AE2990 AFS
CB Handheld Radio for AM, FM and SSB

Servicemitteilung zu AE 2990 AFS v. 21.2.2011

Service Note 2990 AFS issued 21. 2. 2011

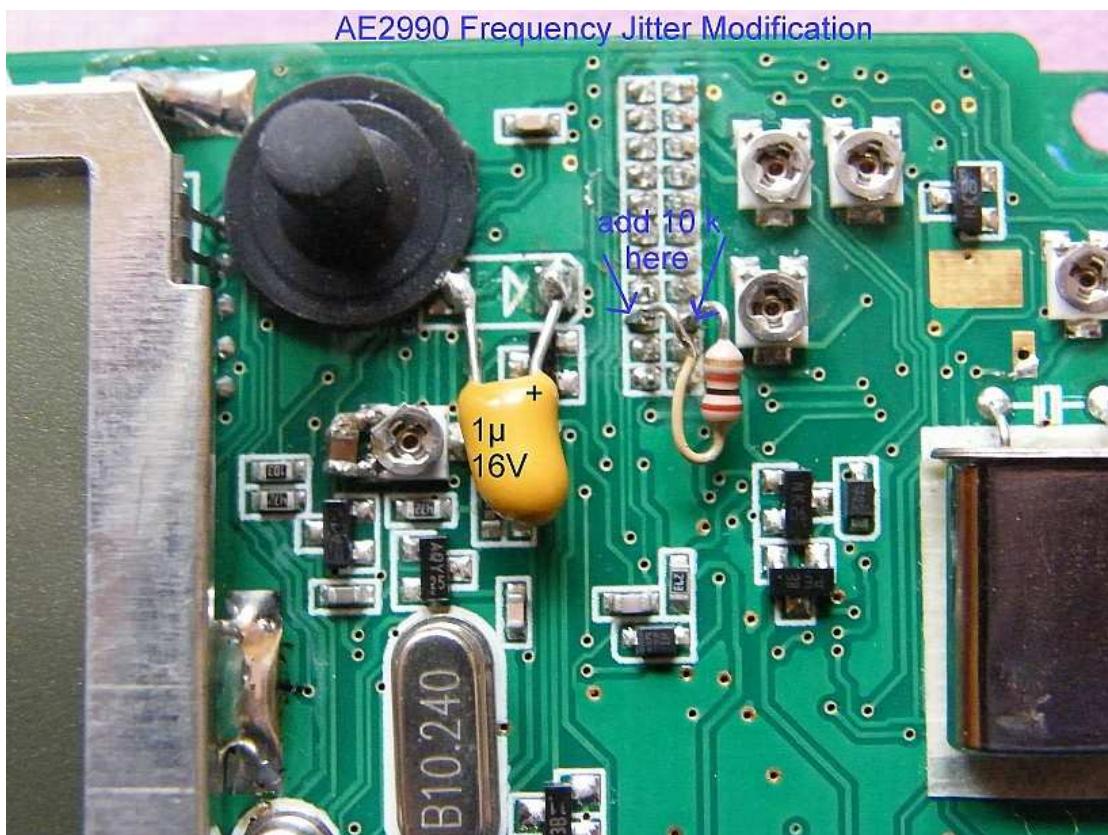
Bei einigen Geräten der ersten Produktionsserie Dezember 2011 wurde bemängelt, dass die Sendefrequenz in SSB bei starker Modulation einen kurzen Einschwingvorgang vollführt. Dieser äußert sich darin, dass z.B. beim Pfeifen in das Mikrofon der Pfeifton während der ersten 10..20 Millisekunden etwa 100..200 Hz neben der Frequenz liegt. Eine Gegenstation wird den Ton als nicht konstant bezeichnen, er ist zuerst neben der Frequenz und wird dann sauber. In Foren wird der Effekt von den Usern als „Eiern“ beschrieben, technisch trifft der Begriff Jitter den Sachverhalt besser.

Ursache: Der Lastwechsel der ansteigenden Sendeleistung bei SSB beim ersten Sprechen bewirkt eine unerwünschte HF Rückwirkung auf den VCO. Die Phasenregelschleife erkennt das als Frequenzablage und regelt nach. Das Regelverhalten reagiert dabei kurzzeitig wie ein Überschwingen.

1. Änderung eines Standard SMD Elkos von $2.2\mu\text{F}$ in einen Tantal-Elko $1\mu\text{F}$ (gelb) in der Phasenregelschleife nach obenstehendem Foto.

2. Zusätzlich kann man auch noch einen **zusätzlichen Widerstand** von ca. $10\text{ k}\Omega$ über die im Bild gezeigten Kontakte des Pfostensteckers (3. Kontaktebene von unten gerechnet, entspr. R 203) legen.

Dieser Widerstand wird aber nicht empfohlen, wenn jemand Wert auf gutes Einrasten auch im untersten und obersten der 400 Kanal-Bänder Wert legt (ggf. ausprobieren).

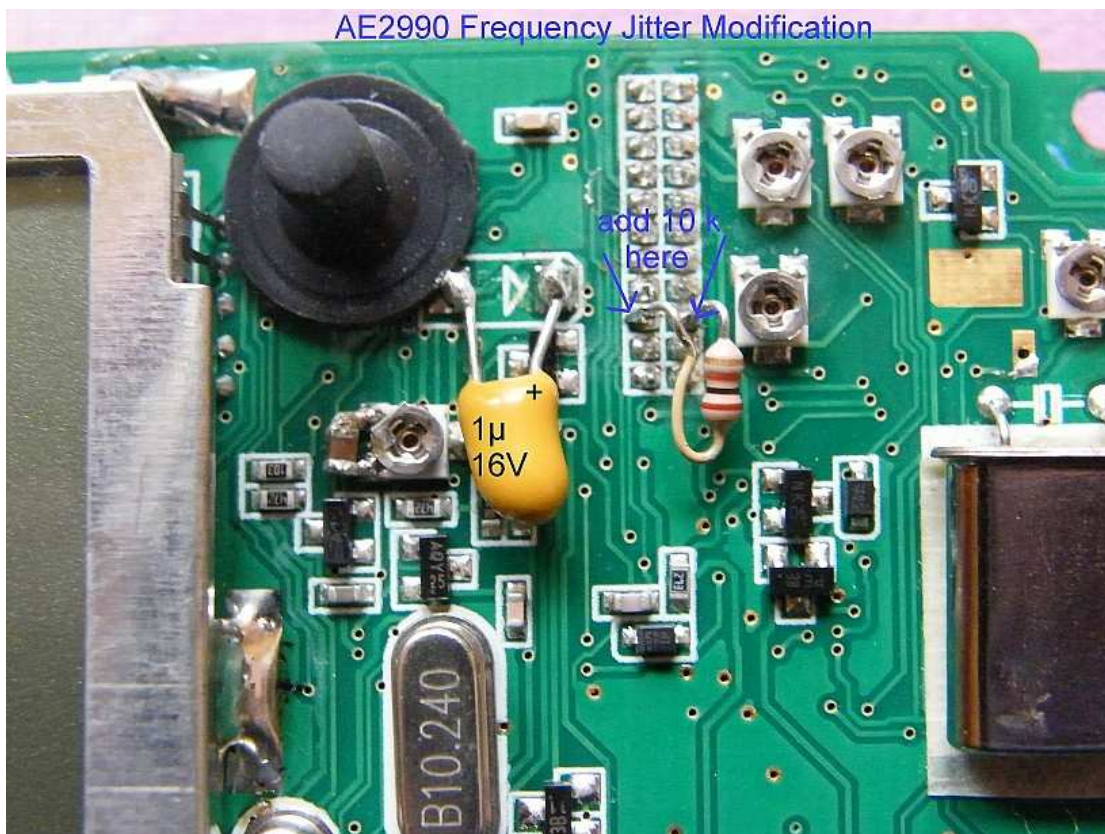
Users reported that units from first production lot show more or less a “frequency jitter” effect during strong SSB modulation. The problem occurs as frequency shift of about 100-200 Hz especially if users produce whistle tones into the microphone during the first 10..20 milliseconds of the tone duration. Distant stations report that the tone is not constant and becomes ok later.

Cause: A negative feedback from rising output power with SSB modulation can cause a short time frequency shift reaction of the VCO. The PLL and phase comparator circuits then try to compensate the VCO Varicap voltage.

1. Change the original **SMD standard capacitor 2.2 µF** into a **Tantalum capacitor of 1µF** capacity (yellow on above photo)

2. Additionally the effect can be further reduced by **adding an additional resistor 10 kOhm** parallel to the PCB plug contacts of the third row (seen from bottom). (Info: these contact points connect to R 203 on main board).

Because this additional resistor may cause longer lock-in periods on lowest and highest 400 CH band frequencies, we do not recommend this modifications to users who should use this configuration. In that case we recommend to check the lock behaviour with and without resistor.
